ONE SYDNEY HARBOUR

BARANGAROO SOUTH

STAGE 1B - Building R4B

SECTION 4.55

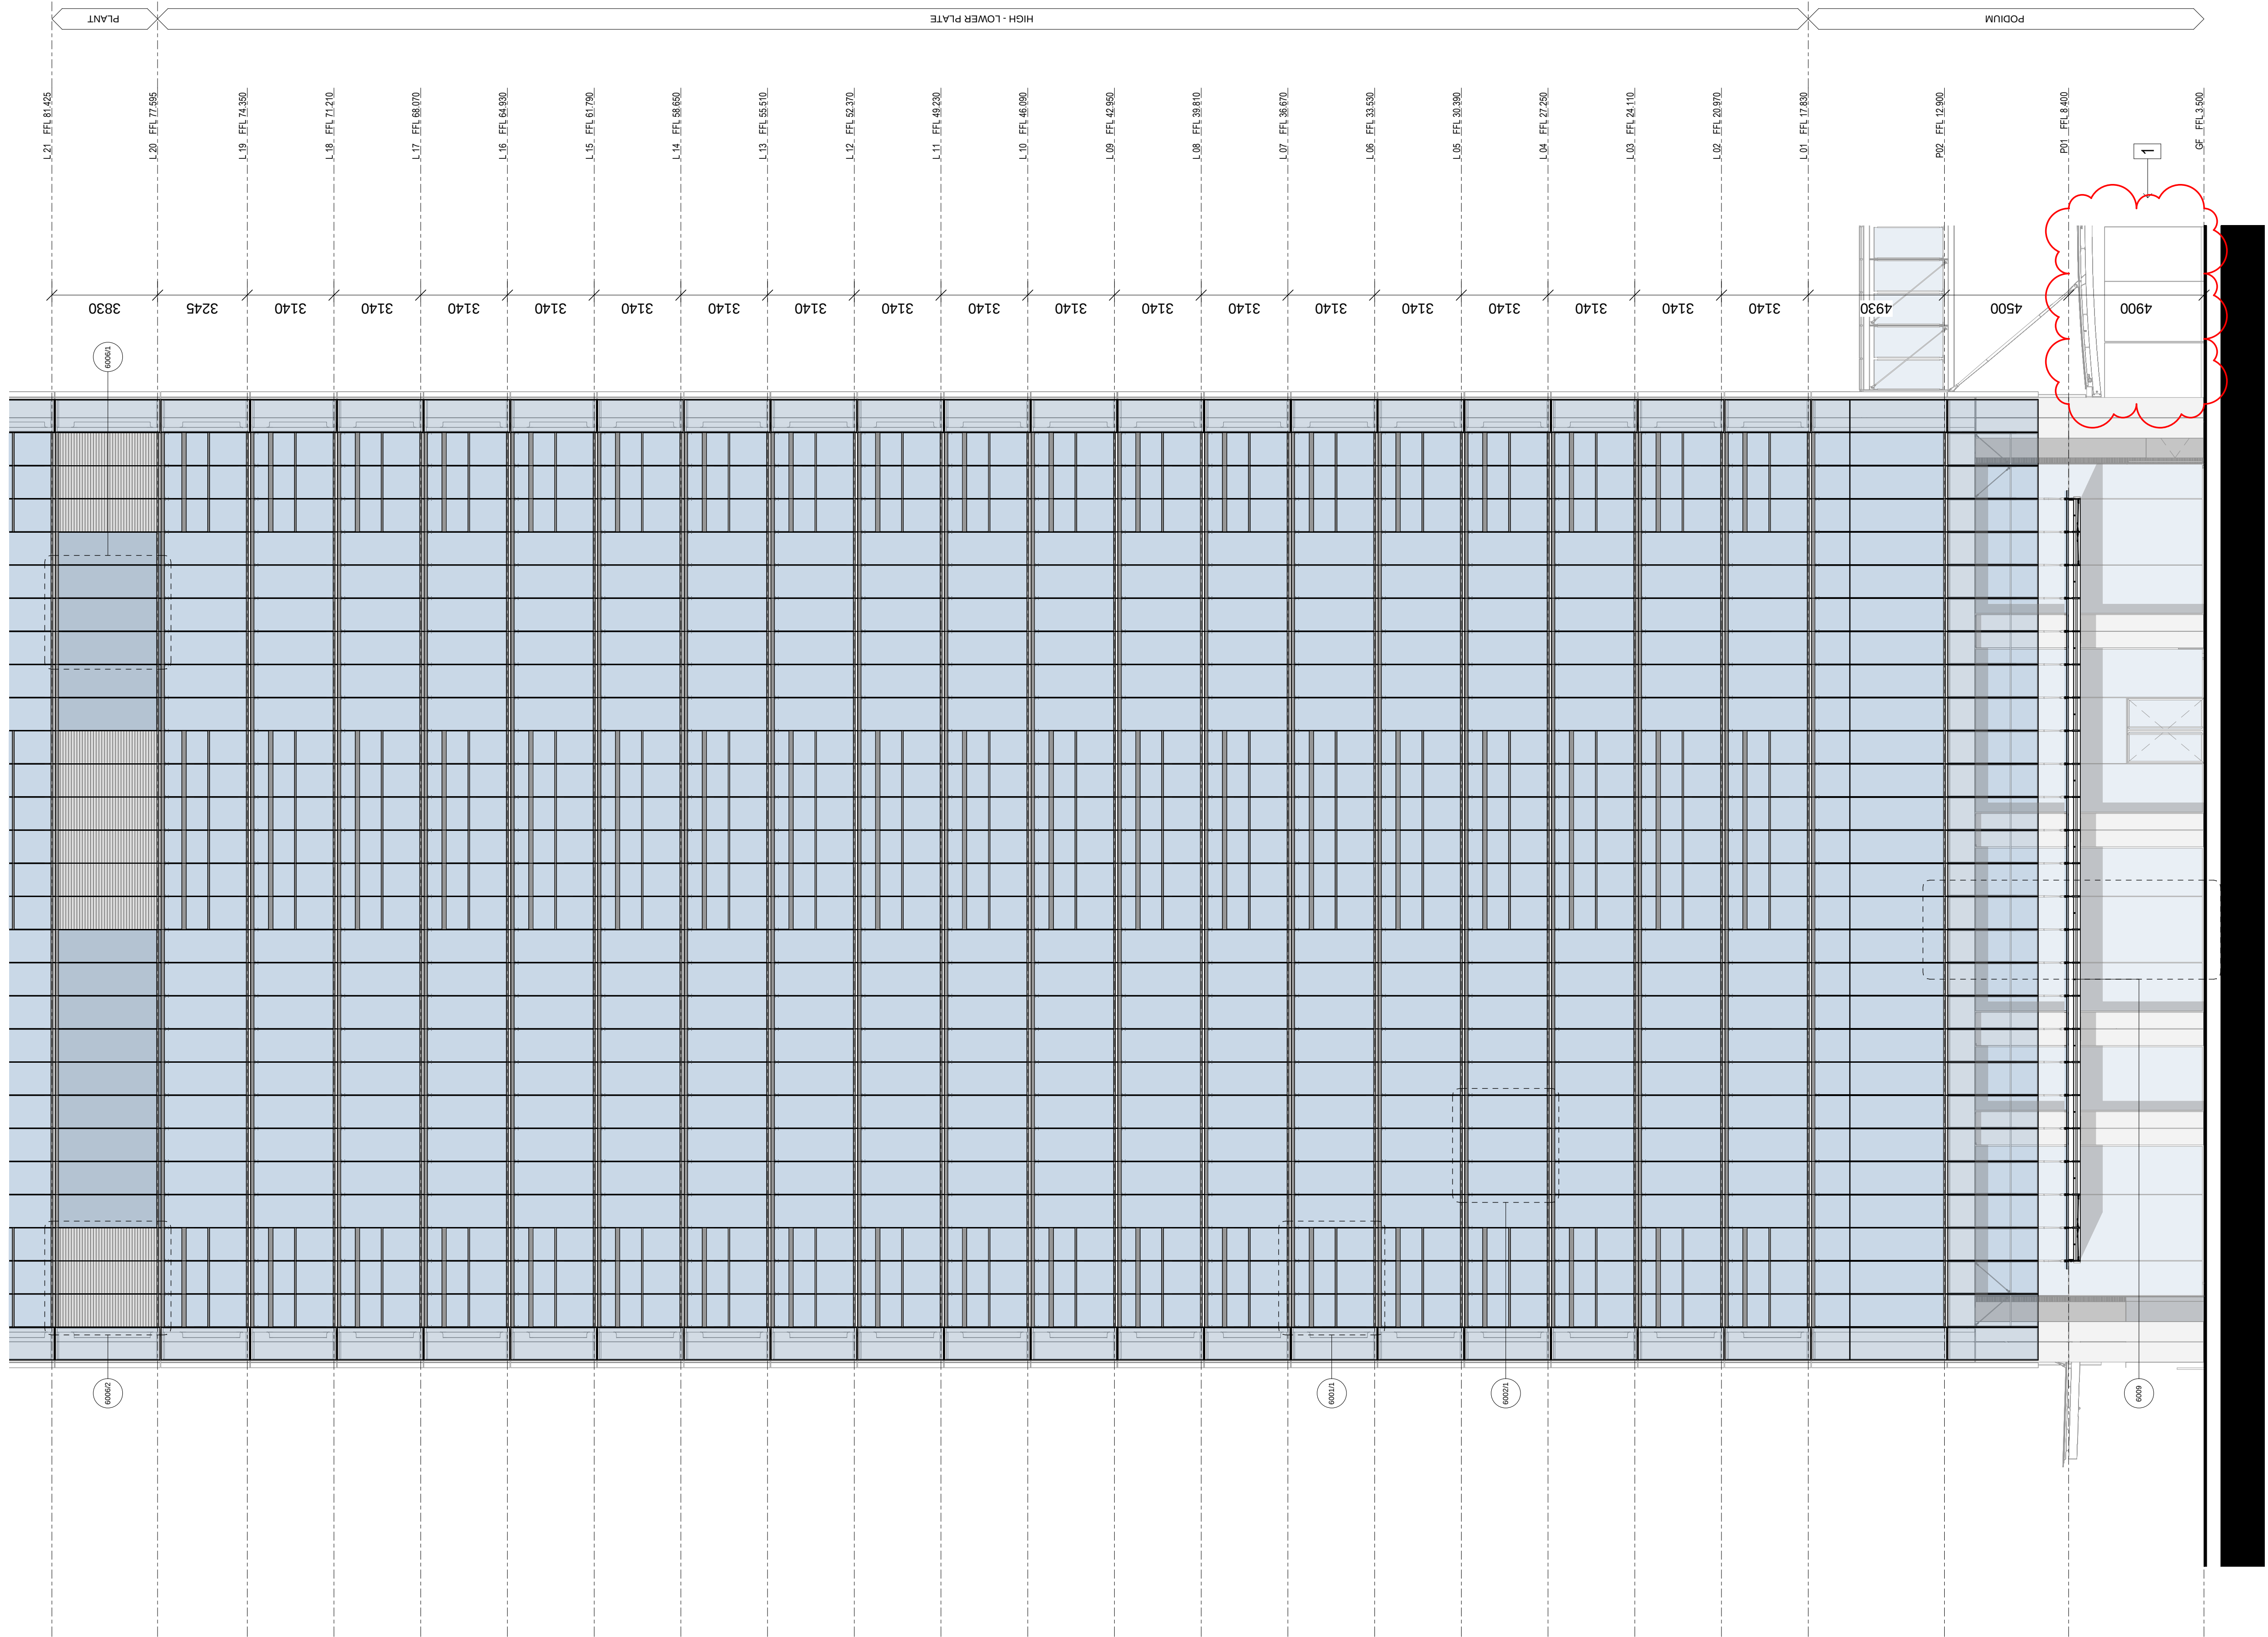
1. UPDATED STRADA WIND BAFFLES PER SECRETARY APPROVAL

R4B ELEVATION SOUTH-EAST (LIFT LOBBY)

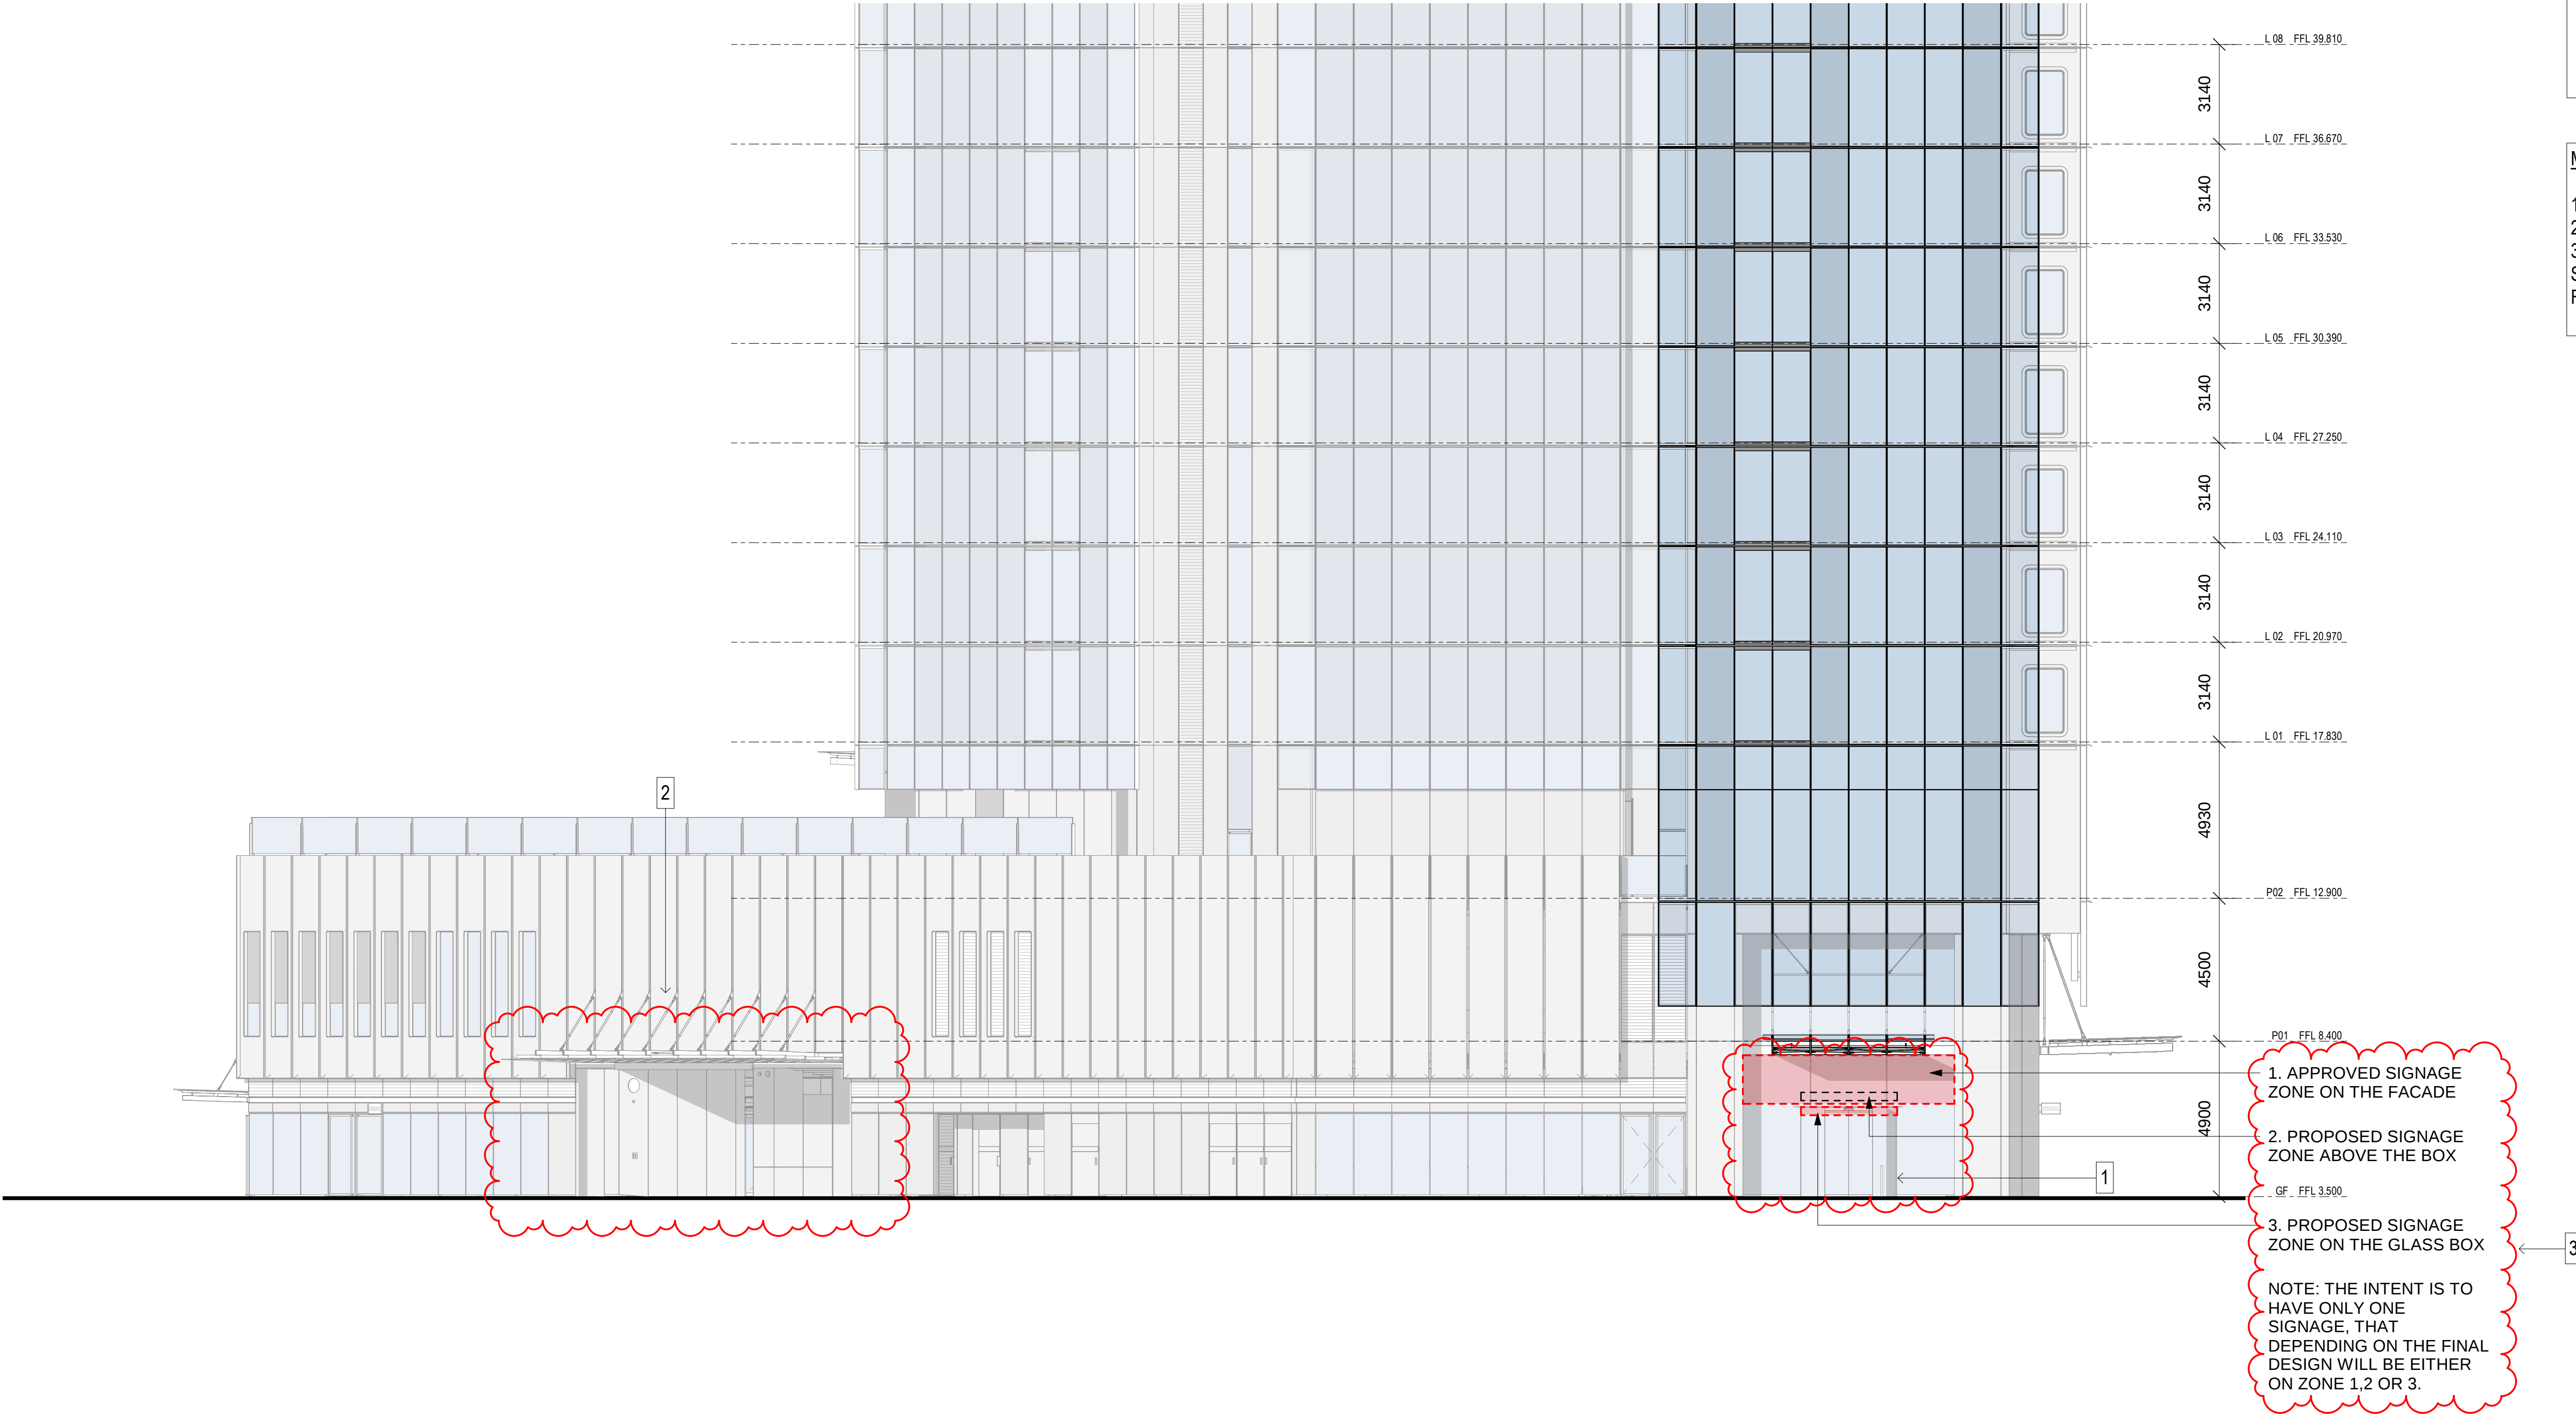
- MODIFICATION:
1. UPDATED ENTRY VESTIBULE DESIGN
 2. UPDATED CARPARK ENTRANCE
 3. REVISED SIGNAGE ZONE (SEE SUPPLEMENTARY DESIGN STATEMENT FOR FURTHER DETAILS)

R4B ELEVATION SOUTH (WATERMANS QUAY)

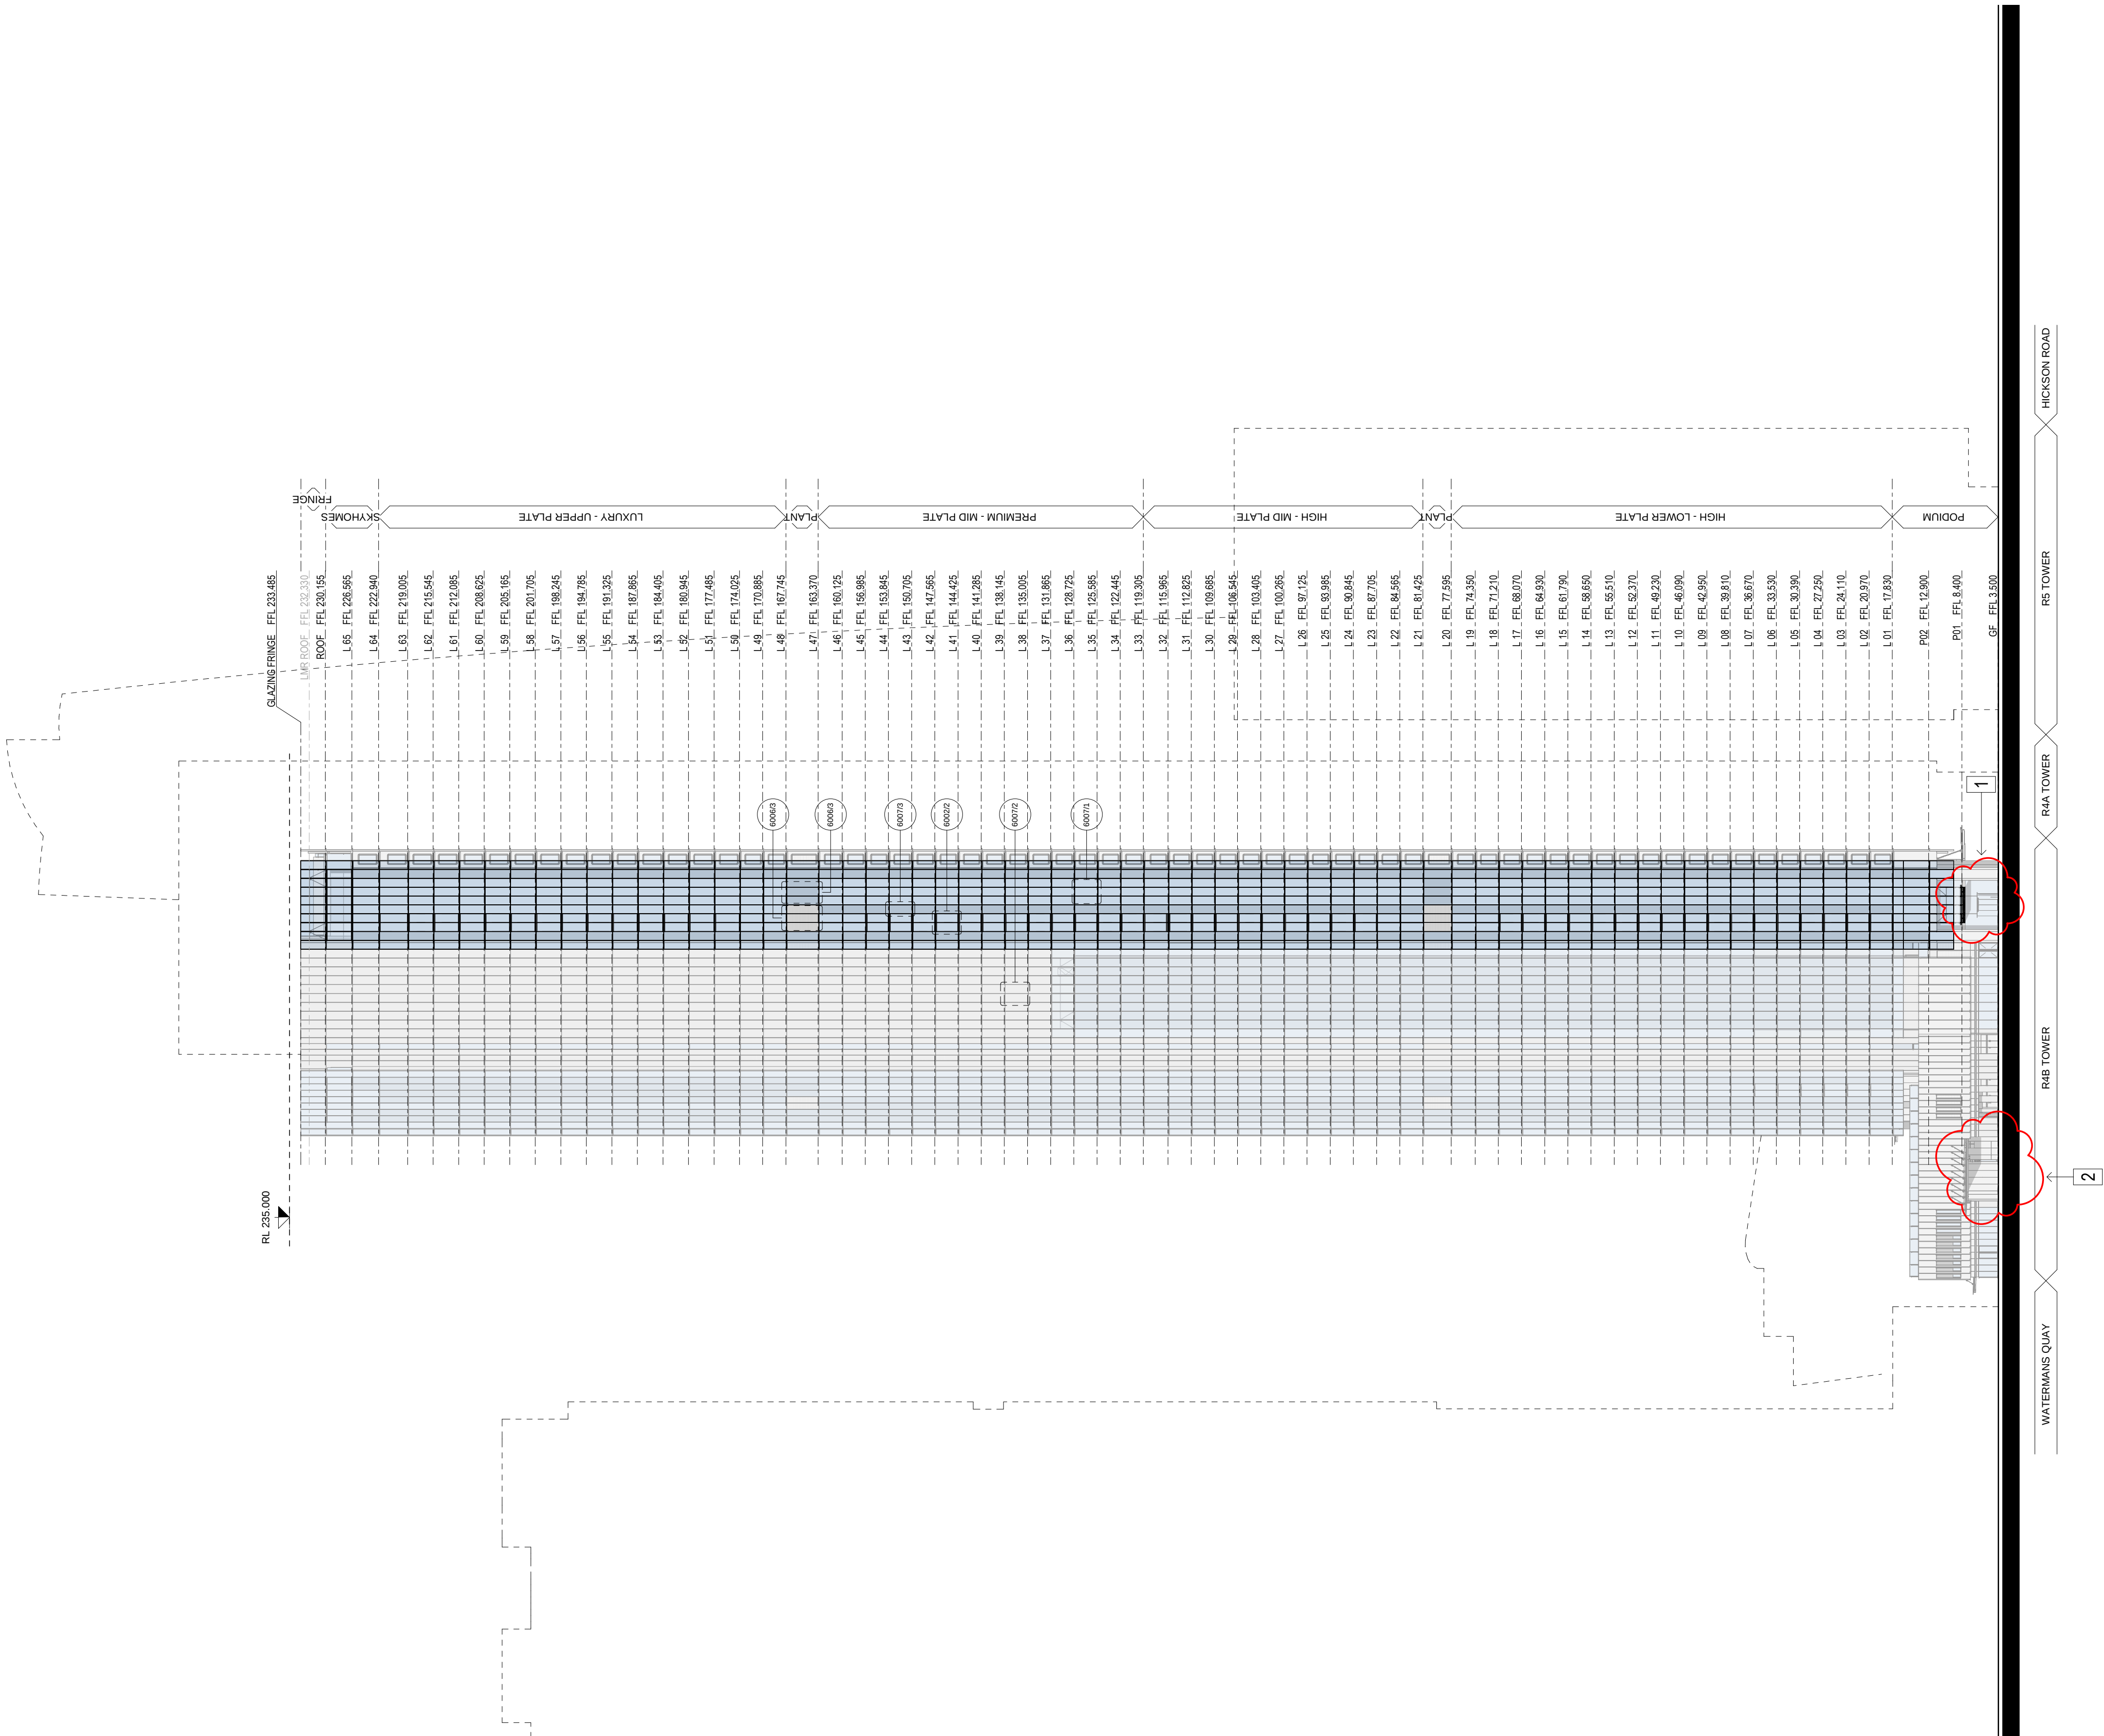
1. UPDATED ENTRY VESTIBULE DESIGN
2. UPDATED CARPARK ENTRANCE
